City of West Linn
PRE-APPLICATION CONFERENCE MEETING
July 17, 2008

SUBJECT: 6-lot PUD subdivision at 19650 Suncrest Drive.

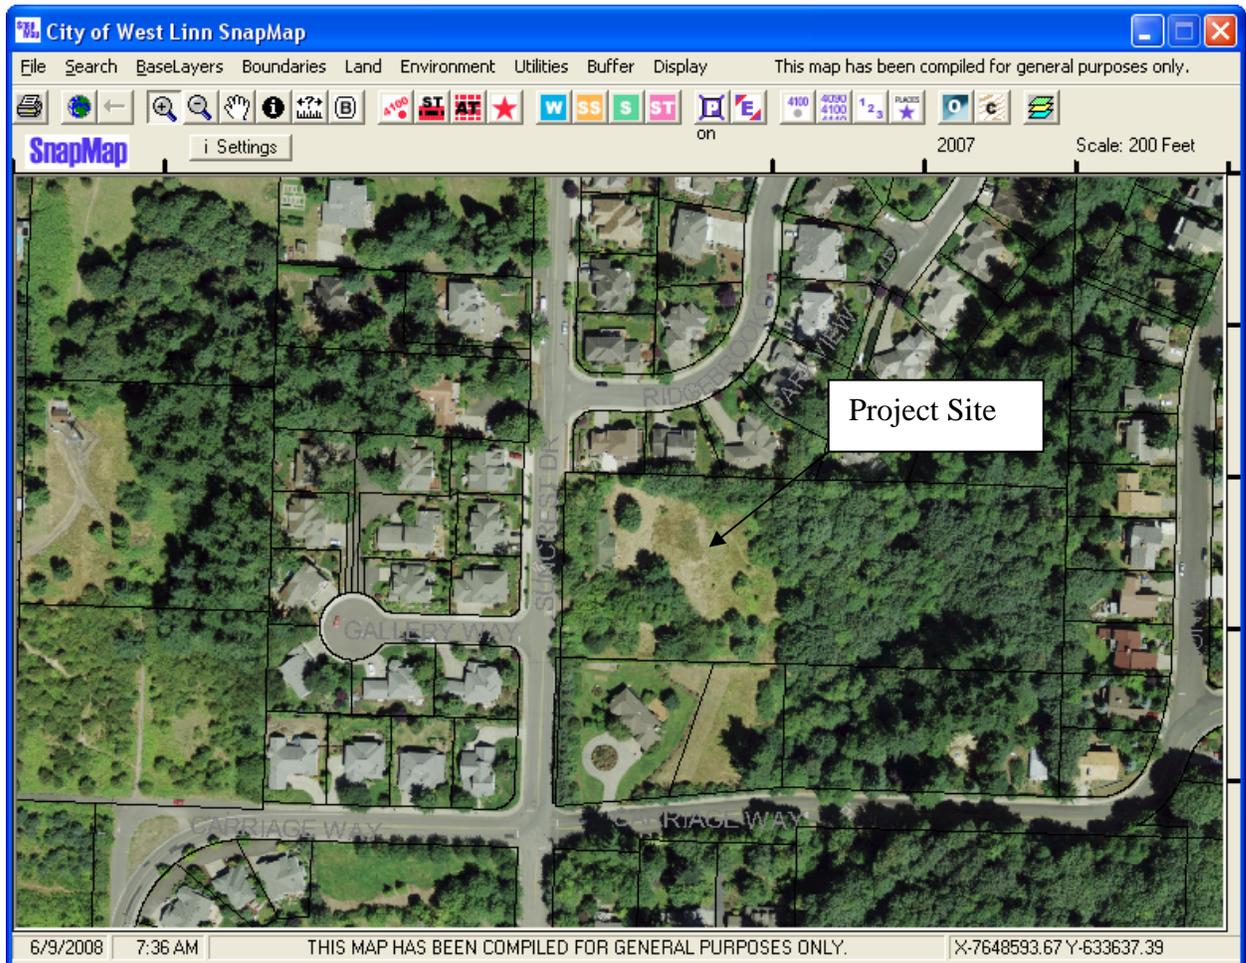
Tract A is presumably provided for a storm treatment/detention facility. Per GIS it is at an elevation higher than the house will be on lot 6. Perhaps the lots on the east side of the access easement should be reversed with the treatment facility.

There is a distinct top of ravine, but it is over 150 feet from the creek itself throughout the property. Therefore the border of the transition area should be considered to be the line 200 feet from the creek, rather than measuring this from the top of the ravine (per Table 32-1 in CDC 32.050[D]). This "200 foot line" happens to be similar in location, but not exactly so, to the top of the ravine, so it would require virtually no reconfiguration of the conceptual plan except for modification of Tract B's boundaries. Since the transition area itself is required to be dedicated as its own tract or easement, Tract B should include anything between this "200 foot line" and the creek, and is welcome to include any areas further west than this that are still below the top of the ravine. Per Table 32-1, no

structures shall be built within 215 feet of the creek (15 feet from this line), and no development at all (minus city-requested trails) can be within 200 feet of the creek without both a Water Resources Area permit and a Class II Variance as well. It appears as if all of the houses will easily be able to be built further away than this. The City prefers Tract B to be dedicated to the City rather than a conservation easement; it is possible for the applicant to apply for areas on the far west end of the 200 foot transition area to be conservation easements while leaving the rest for City dedication as Tract B; this may help the applicant fit houses onto the lots as setbacks would be measured from the edge of the lot line, as long as development stayed out of the easement and structures stayed out of the additional 15-foot structural setback.

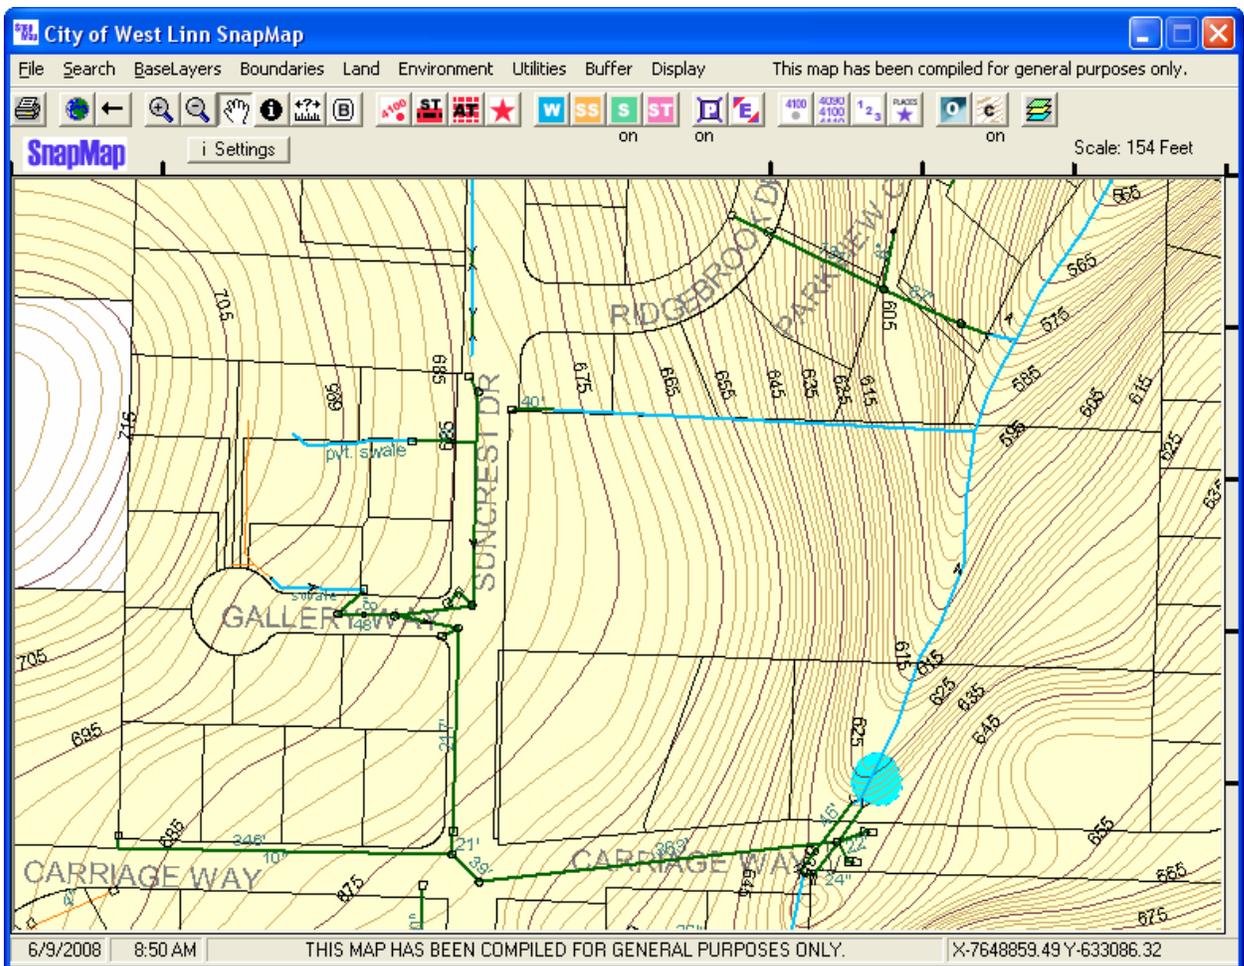
From the City Assessor map, Suncrest Drive current right-of-way is approximately 50' wide with a 36' wide roadway pavement section. Property opposite side of the proposed development had been developed with sidewalk consisting of curb and gutter along their properties. Right-of-way for collector varies between 48', 58', and 72' depending upon whether or not parking, median, and bike lane is required.

In order to be consistent with adjacent developed property and preserving the right-of-way for future roadway widening, this property shall be required to dedicate 10' along the property frontage.

The City TSP identifies that pedestrian access is deficient along part of Suncrest Drive. The TSP also identifies that sidewalk is only available on the opposite side of the proposed development. ***Thus constructing new sidewalk connected to the existing sidewalk from the north shall definitely be required for this development.***

The TSP does not identify bike lane is required along Suncrest Drive. However the City SDC Capital Improvement Projects has indicated that bike lane plus sidewalk between Carriage Way and Valley View Drive must be added. ***Therefore bike lane and striping shall be required along this project frontage.***

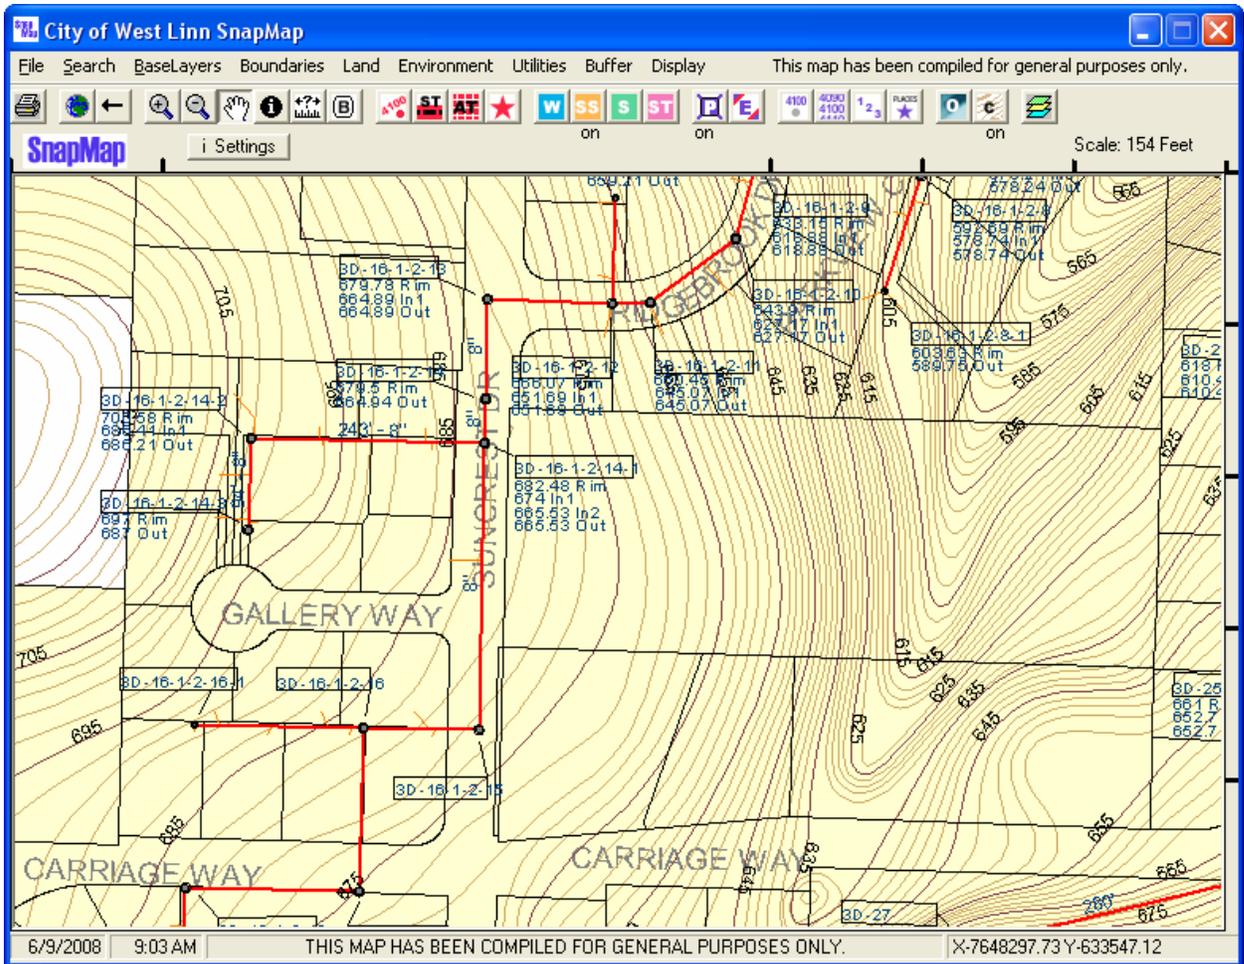
From the City GIS snap map, run-off flows from the front of the property toward the middle of the property where the existing creek located.

From city record indicates that the property is currently undeveloped. Run-off is sheet flow over the pervious area from front to the wooded area in the back of the property and eventually ending up in the existing creek in the back.

When the property going to be developed, street run-off along the project frontage shall be captured and treated as well as detained before discharging to the existing public storm system. Stormwater treatment facilities designed in according to the City of Portland Stormwater Management Manual. The City of West Linn Public Works is in the process of developing and implementing the use of rain garden as a stormwater treatment facility. Detail of rain garden will be handed out during the pre-app meeting if needed.

Developments that create 500 square feet of new impervious shall provide treatment for stormwater run-off.

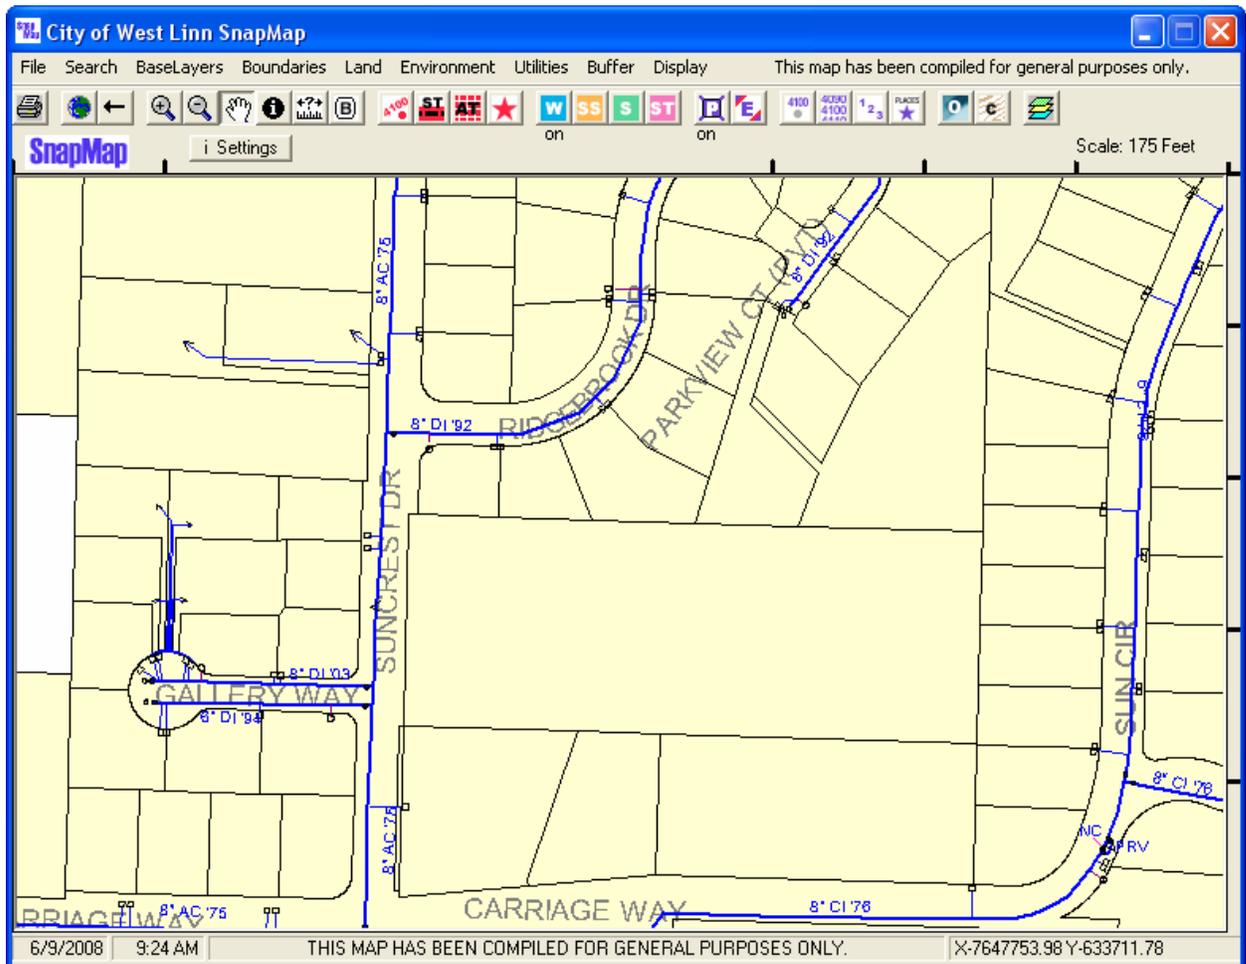
From the City record indicates that there is existing public sanitary sewer system available for connection along Suncrest Drive. However the topography indicates that constructing gravity feed sanitary sewer to the existing sanitary sewer system on Suncrest Drive may be a challenge since the property is much lower in the back in comparison to the roadway.

Another possible connection can be obtained is through the existing sanitary sewer located on 2269 Parkview Court. It will be an optimal gravity feed connection if the developer can obtain an easement from this property owner and extend the existing sanitary sewer to feed the onsite proposed sanitary sewer system. He may also be able to partner/share costs with 1810 and 1822 Carriage Way who may be interested in hooking up to sanitary sewer as well. A minor partition was done in the last 2 – 3 years creating 1810 and I don't know if the City's code allows for new septic tank installations. This may be a way to share the potential costs of obtaining the easement through Parkview Court instead of having to pump by ejector pumps up to Suncrest Drive.
